STAFF REPORT

CITY OF COLUMBUS PLAN COMMISSION (April 8, 2026 Meeting)

Docket No. / Project Title: SUB-26-20 (Tipton Ridge Major Subdivision Preliminary Plat)
Staff: Andres M. Nieto
Applicant: Tim Thomas, PE
Property Size: +/- 107 acres
Current Zoning: RS4c (Residential: Single-family 4) w/ commitments
RMc (Residential: Multi-family) w/ commitments
Location: 7162 West State Road 46, in the City of Columbus.

C3

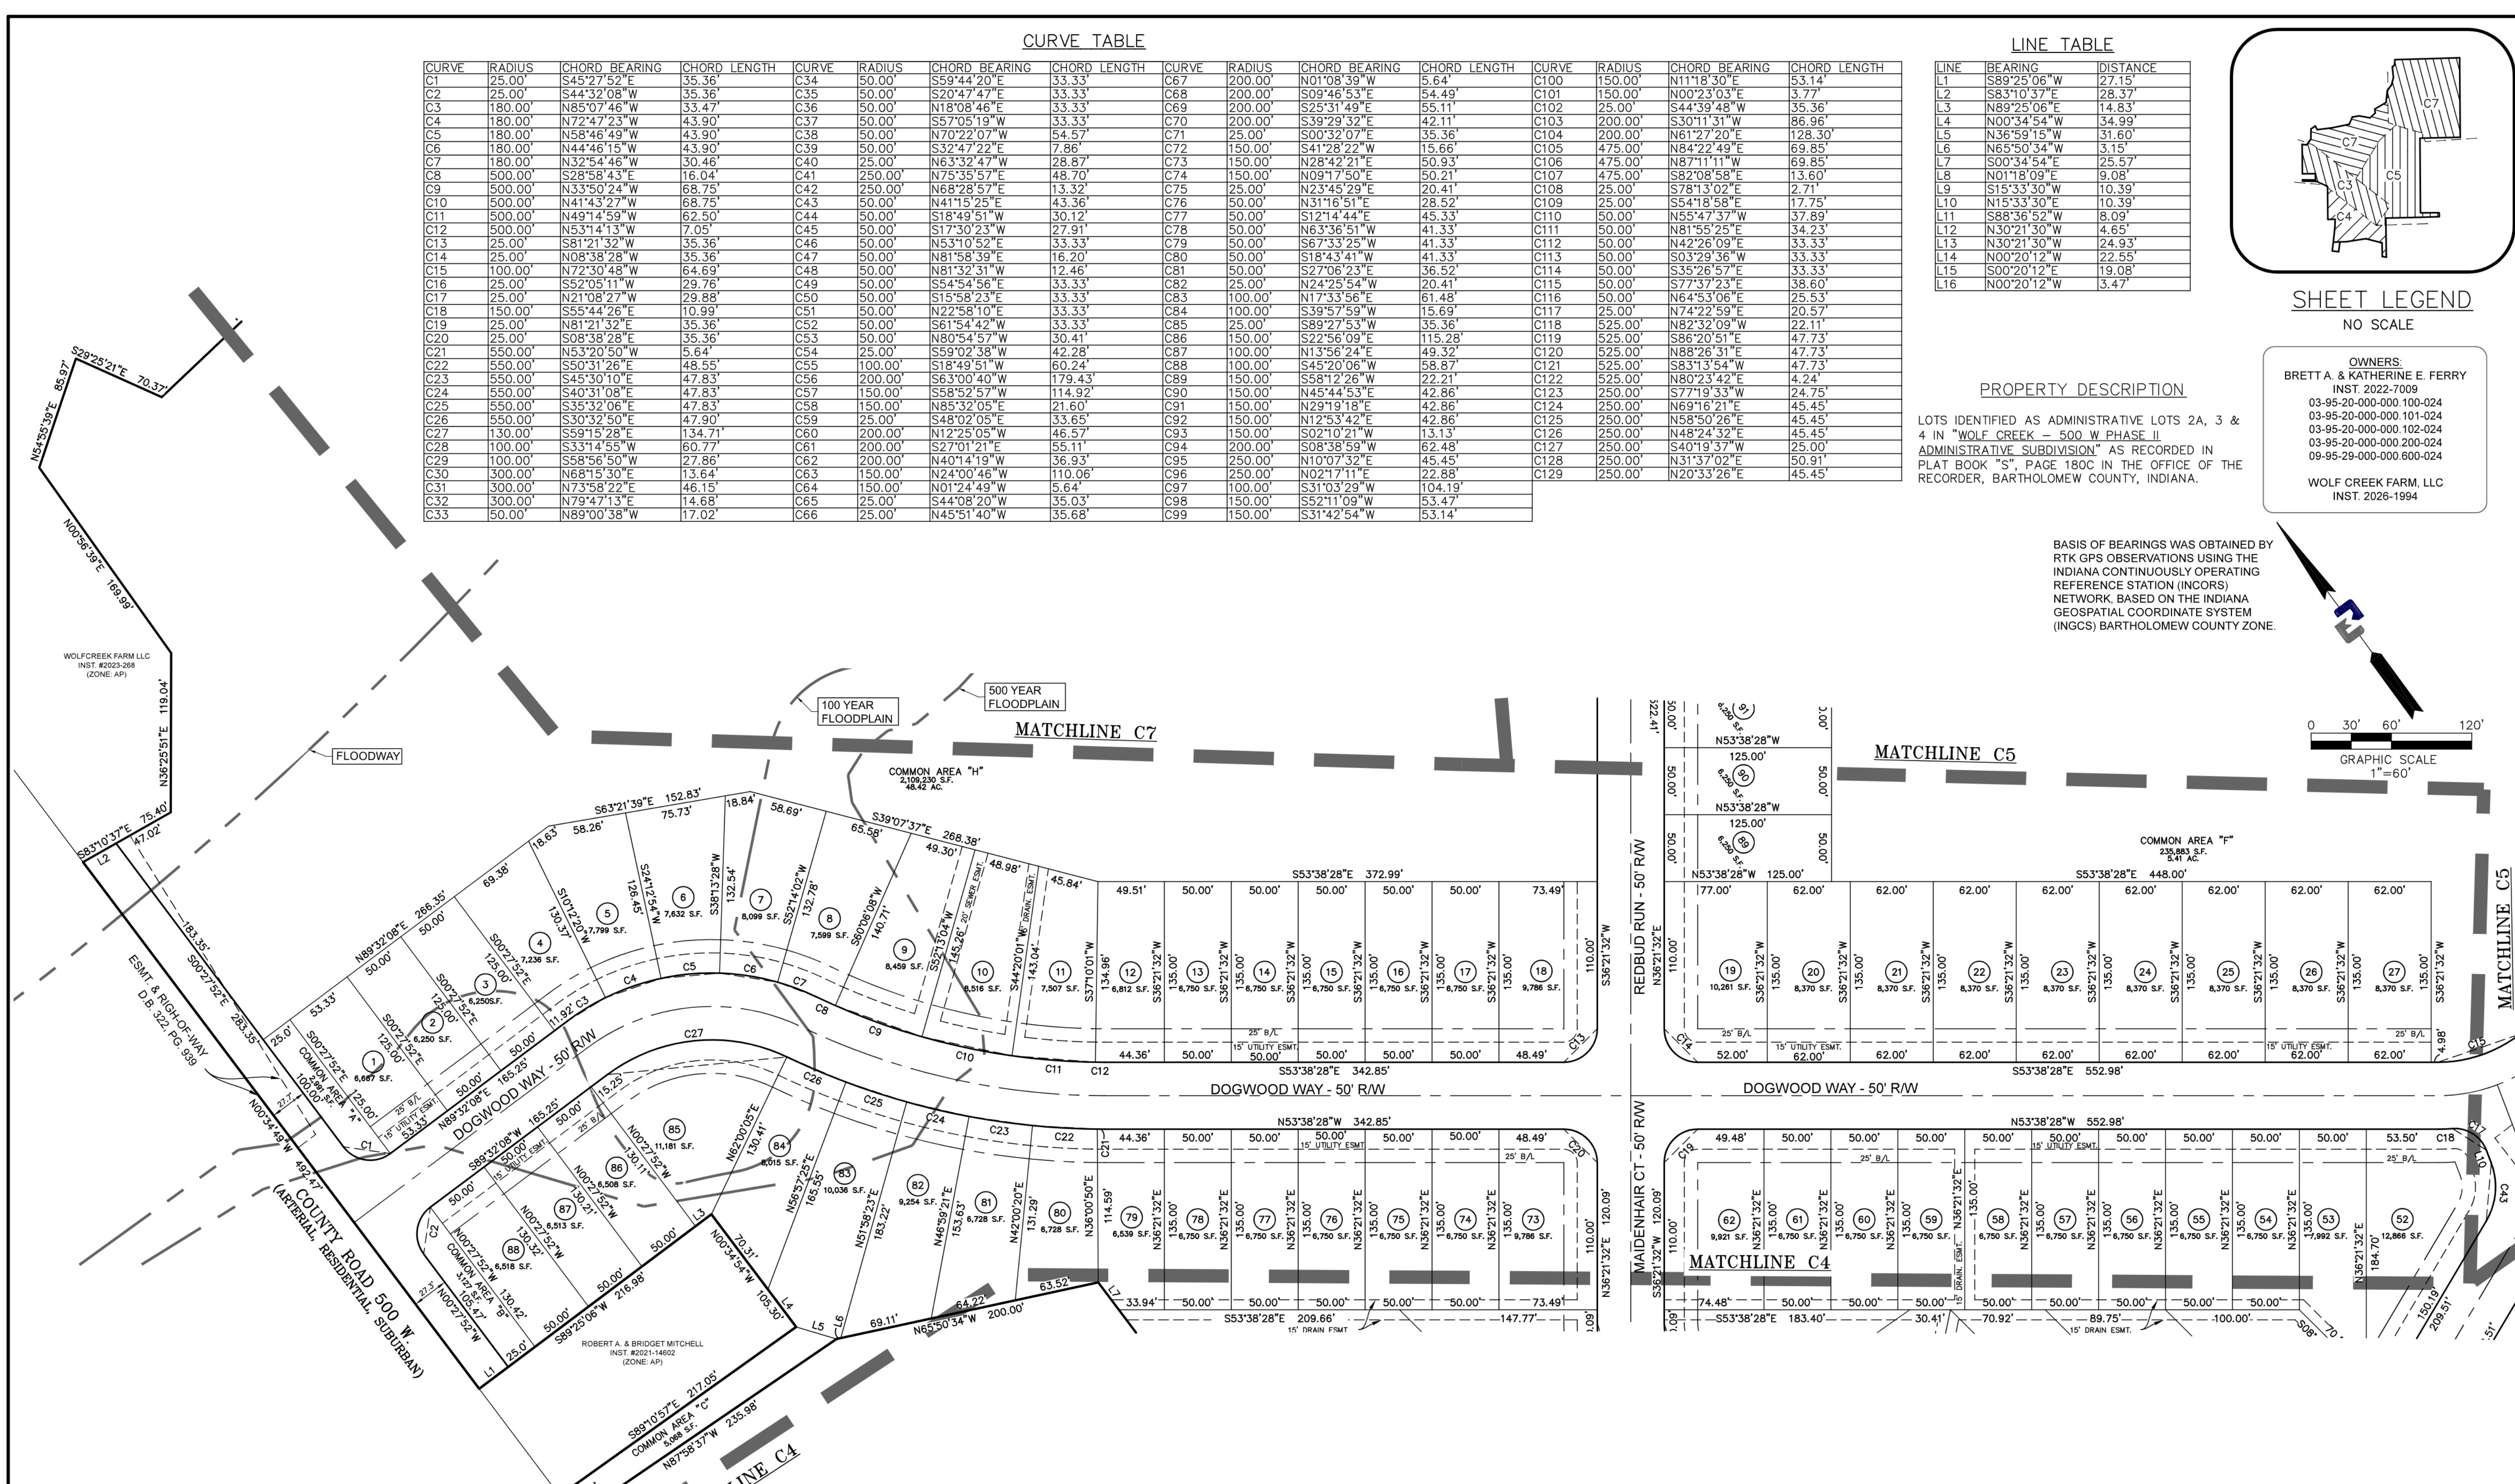
- a. Road classification of 500 West shall be revised to (Minor Arterial, Residential, Suburban).
 - b. Right-of-way to be dedicated shall be revised to 45 feet, per City Engineer's recommendation.

C9

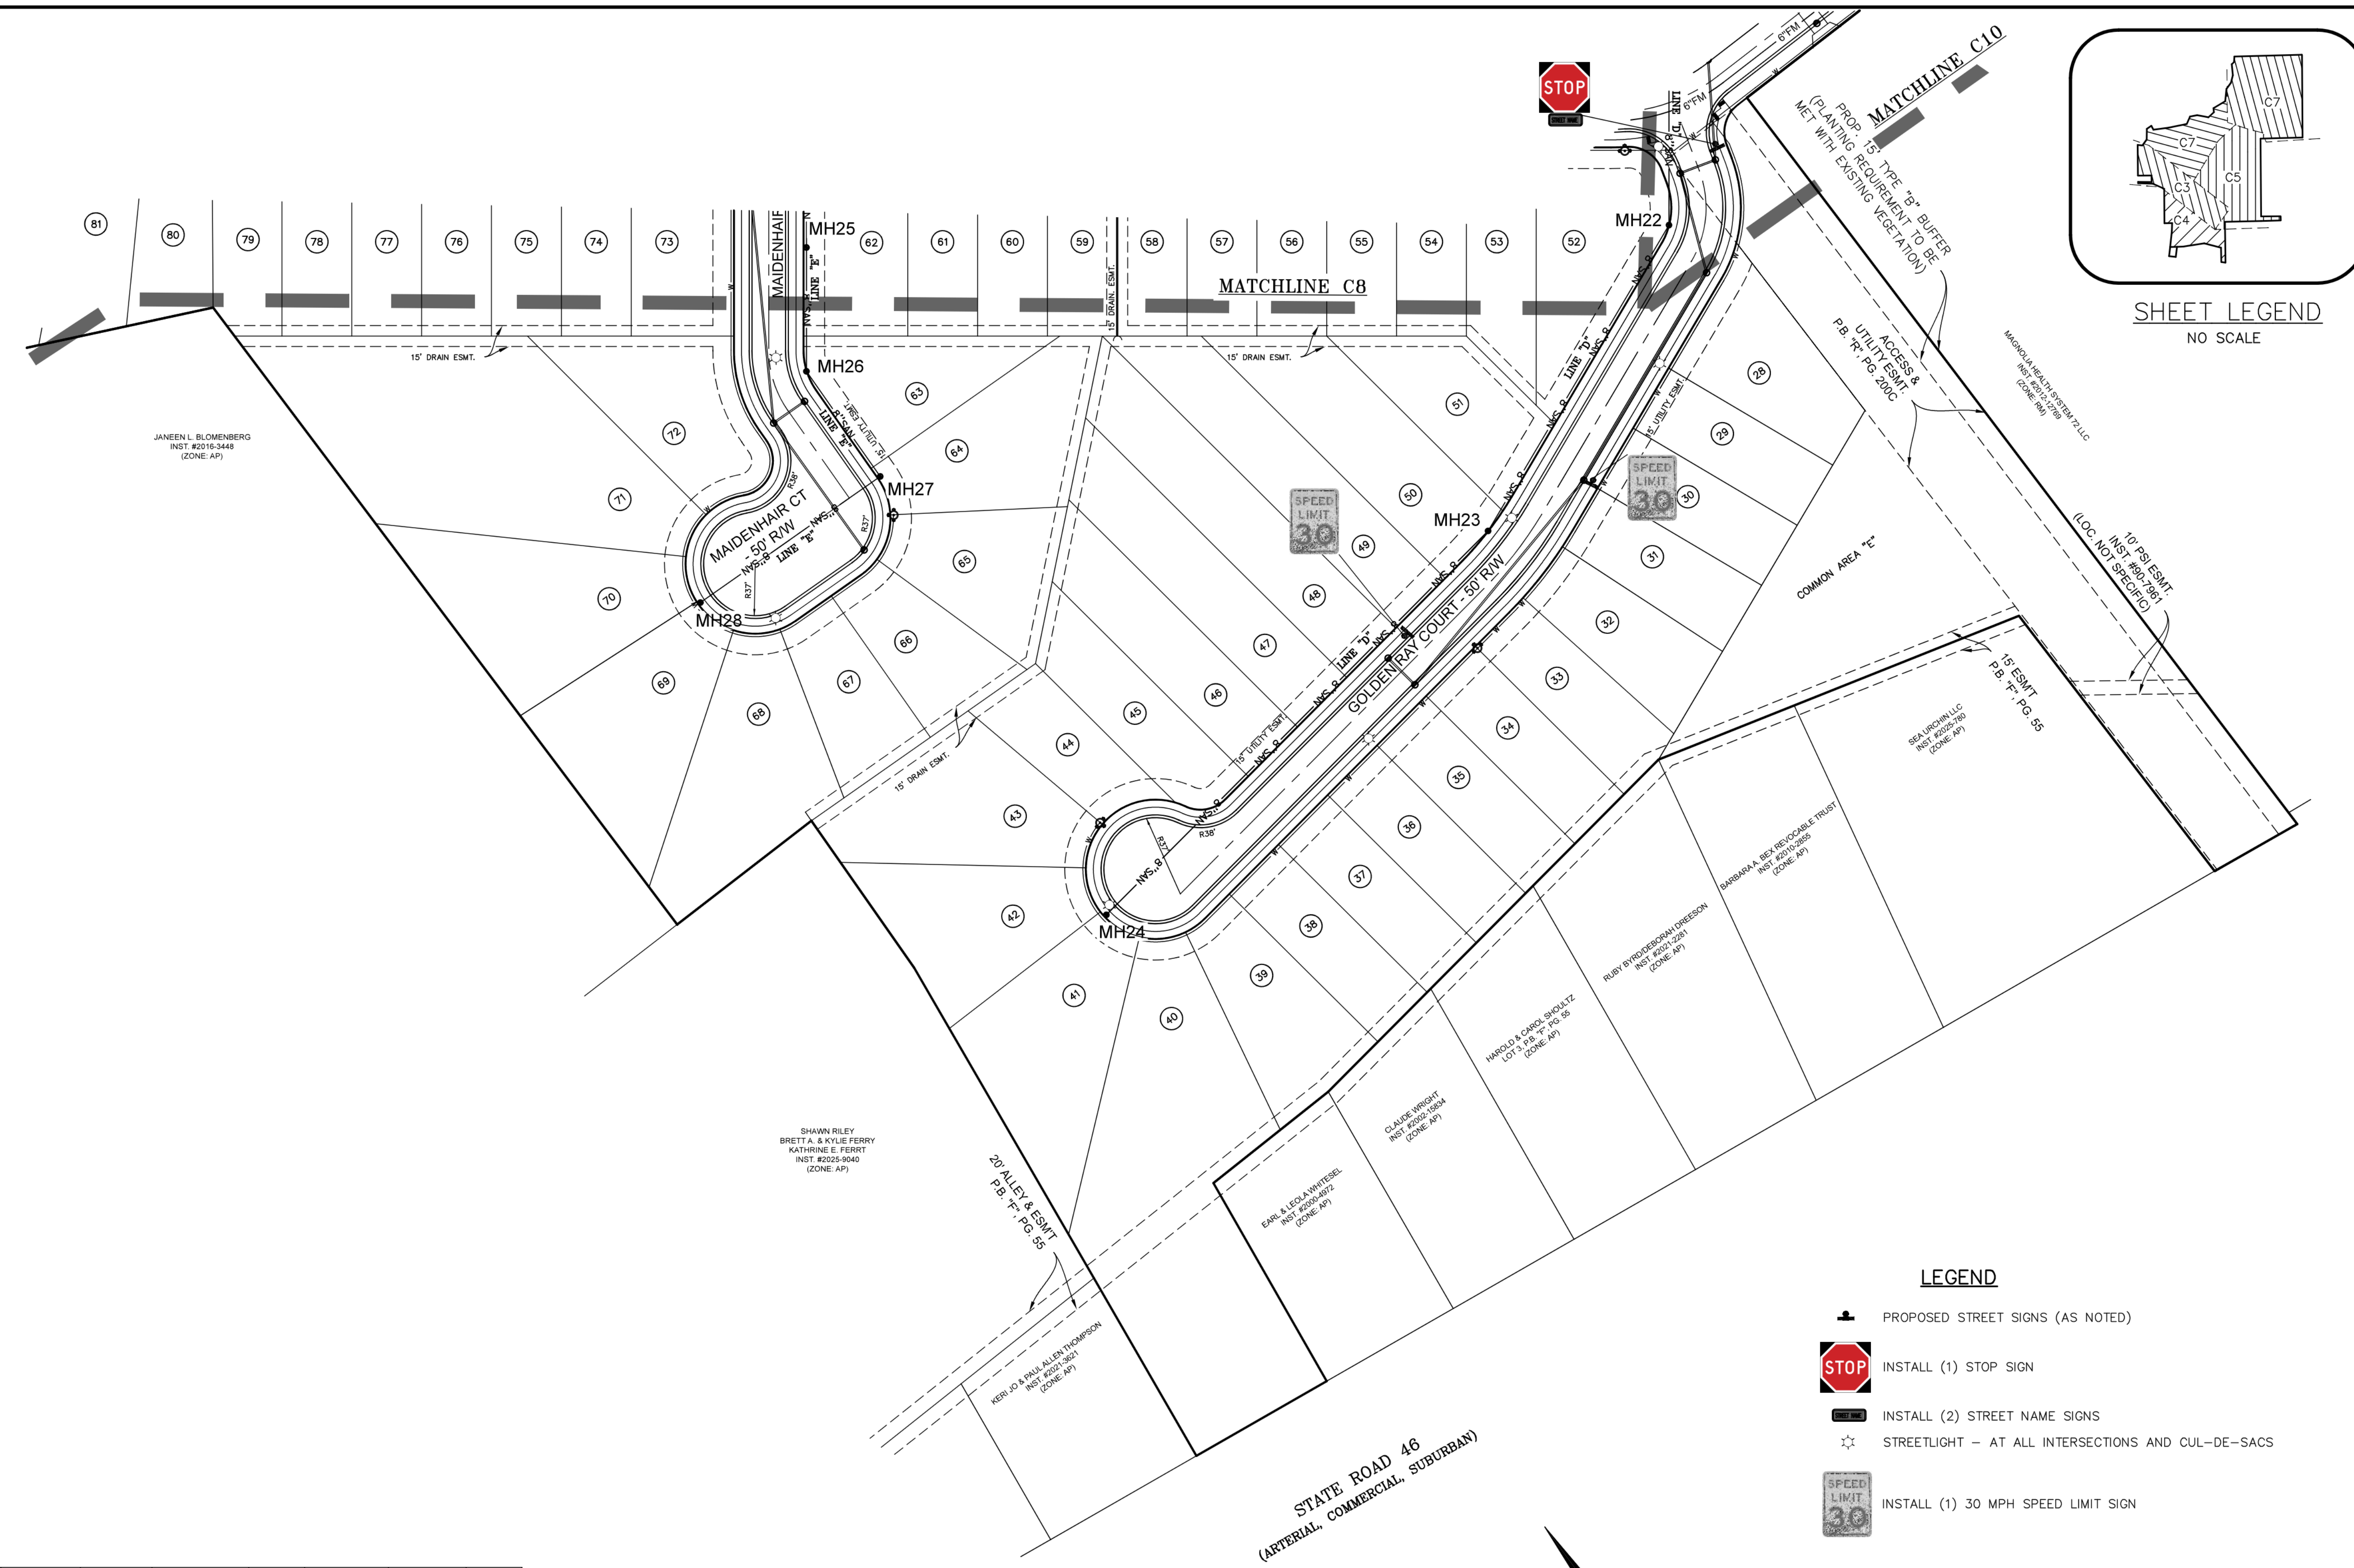
- b. Right-of-way to be dedicated shall be revised to 45 feet, per City Engineer's recommendation.
7. Roadway Plan (Sheet C9):
 - a. The radius of cul-de-sac pavement shall be revised to a minimum of 40 feet, measured from the center of pavement, as required by Table 16.24-1 of the Subdivision Control Ordinance.

C11

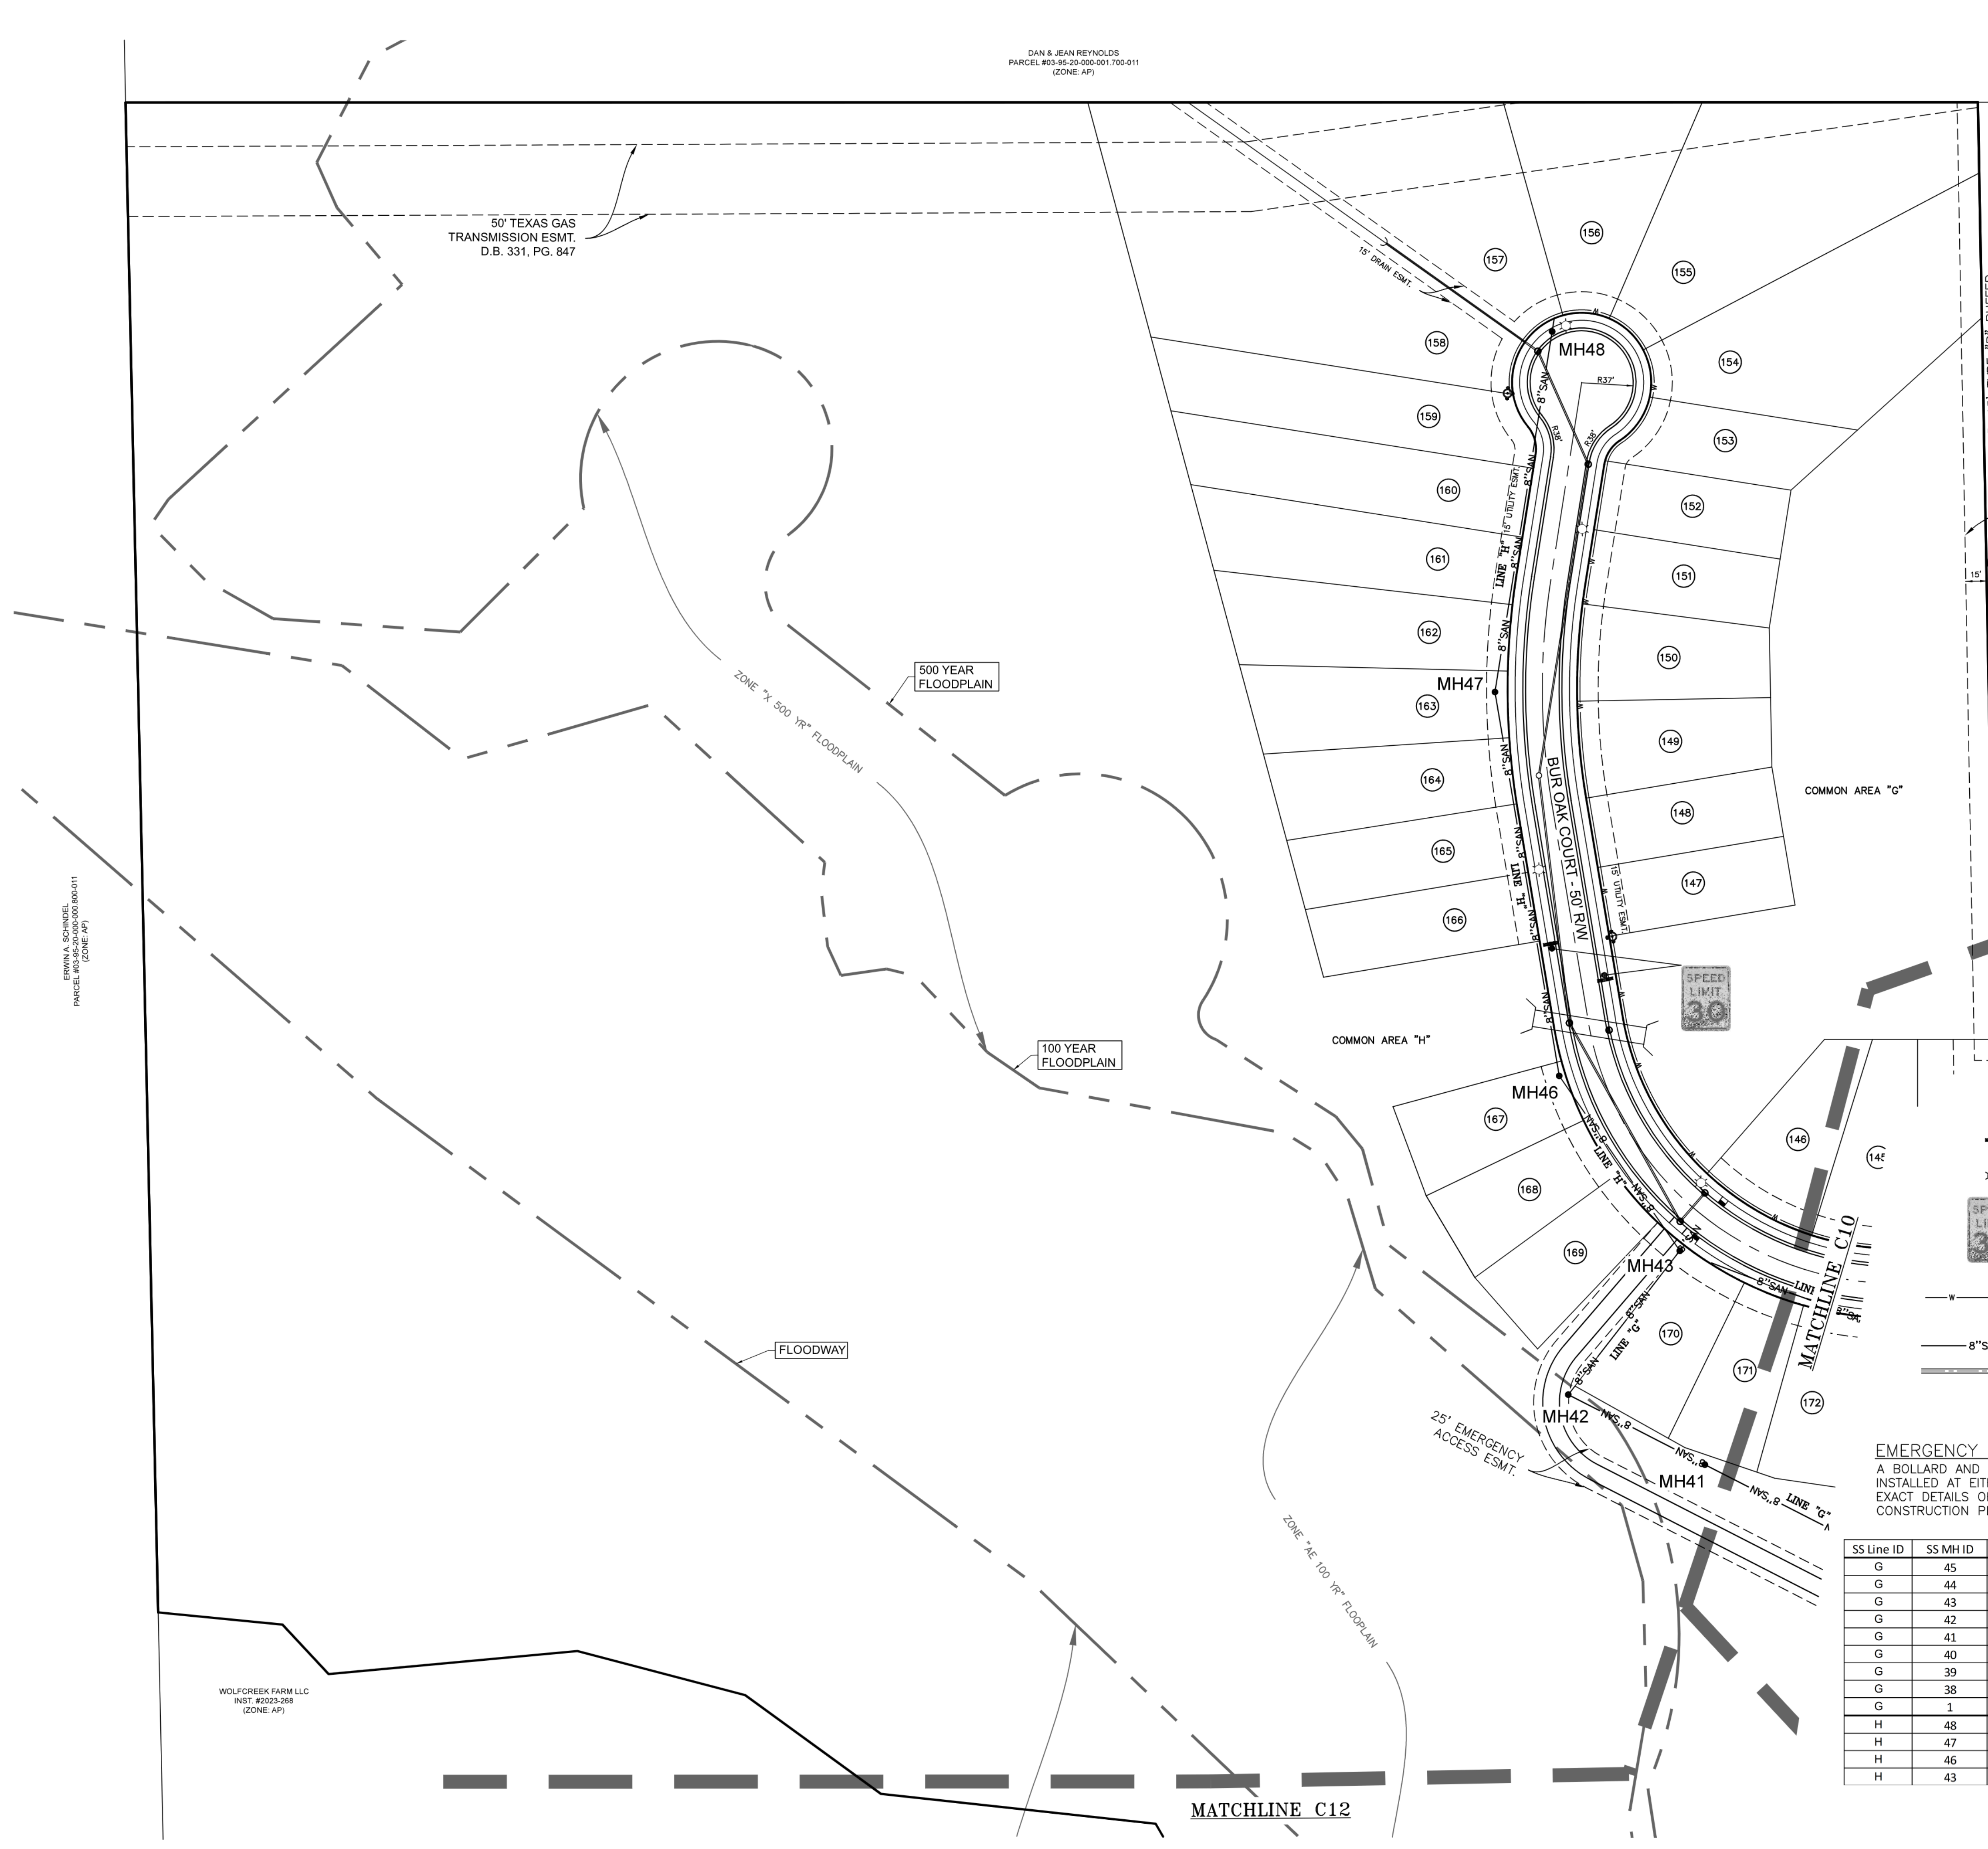
9. Roadway Plan (Sheet C11):
 - a. Curb ramps shown near the beginning of the emergency access easement shall be revised to cross Redbud Run directly across from the easement.

- b. The radius of cul-de-sac pavement shall be revised to a minimum of 40 feet, measured from the center of pavement, as required by Table 16.24-1 of the Subdivision Control Ordinance.
